Case Officer: Harry Chalk
Reference: FG/45/22/T
Location: Corner of Oaklands and Ferring Street, Ferring, BN12 5EG
Proposal: 1 no. holm oak tree - Crown reduction to leave height 13.5m and spread 8.5m and crown lift over road to 5m
Reason given: To maintain cyclical pruning regime

Figure 2 Positions of final cuts

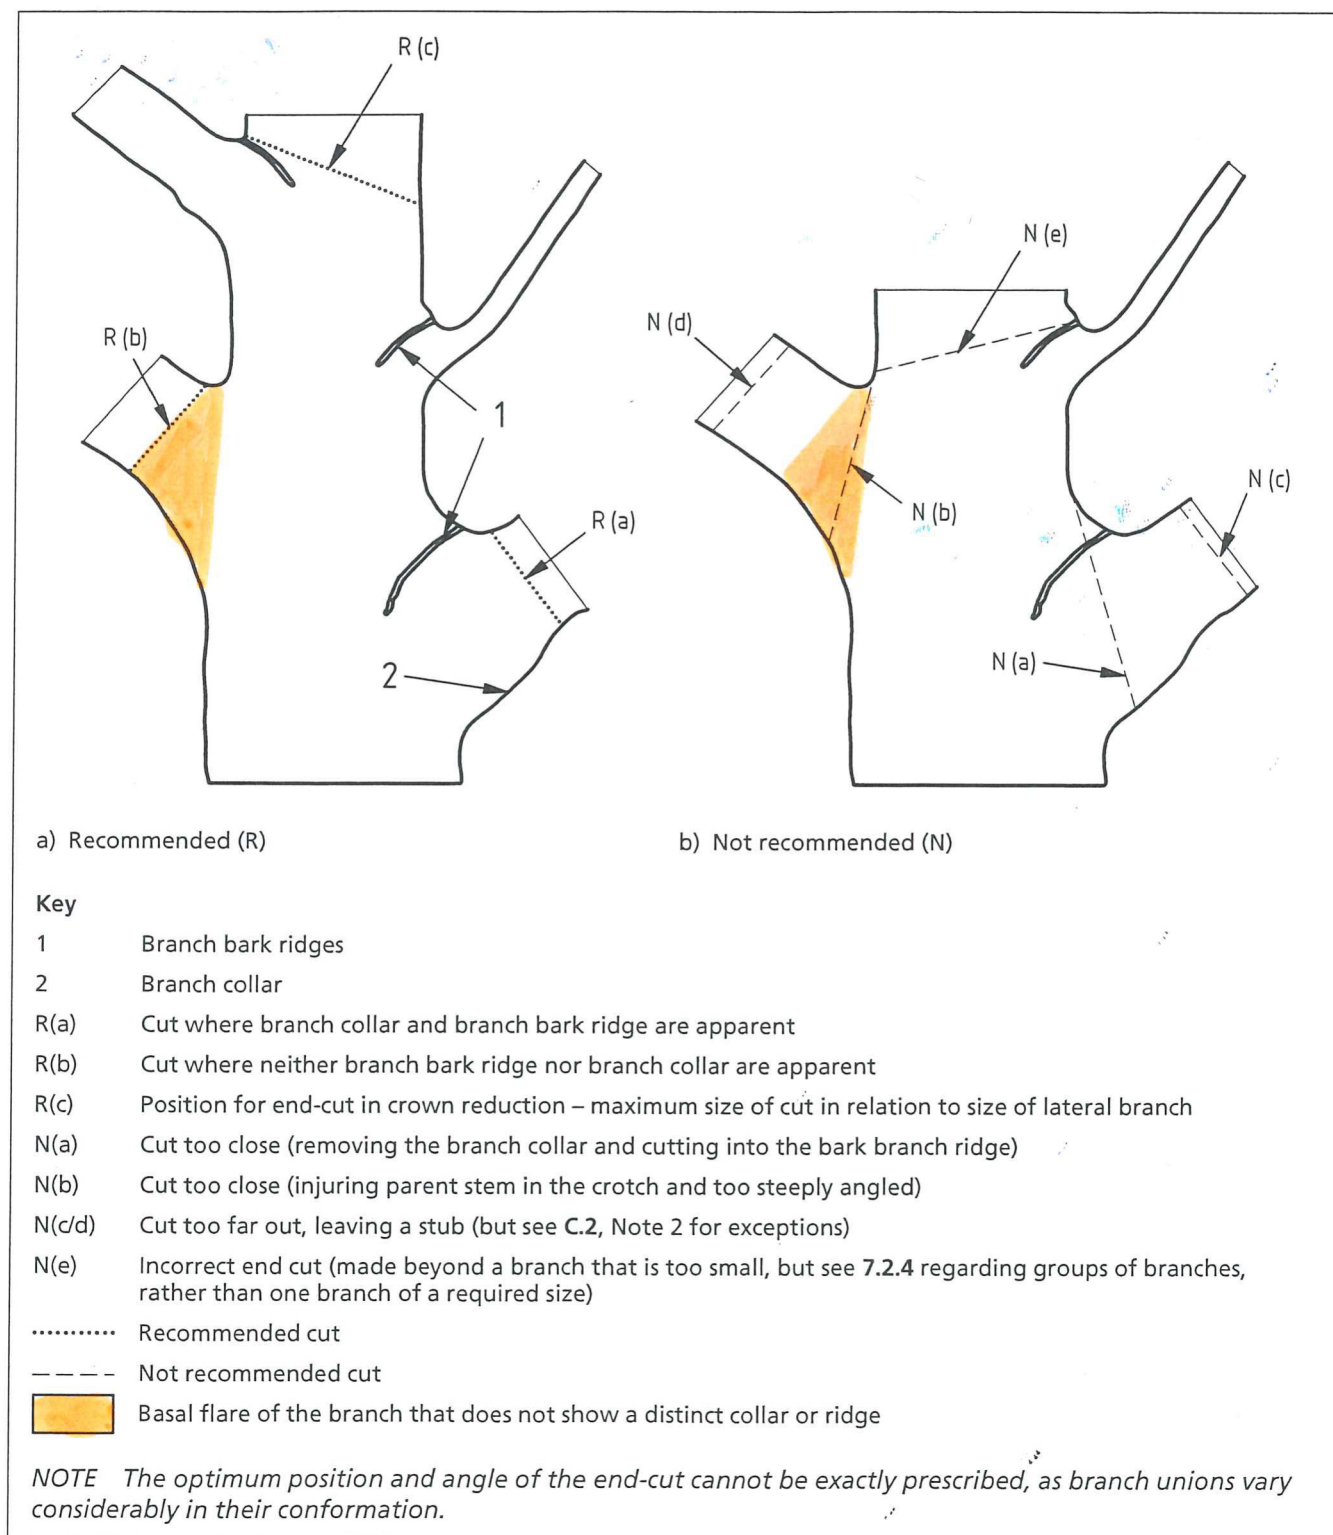
Part a) Where whole branches are to be removed and final cuts made close to the trunk or branch union they are to be made as shown in Figure 2 of BS3998:2010
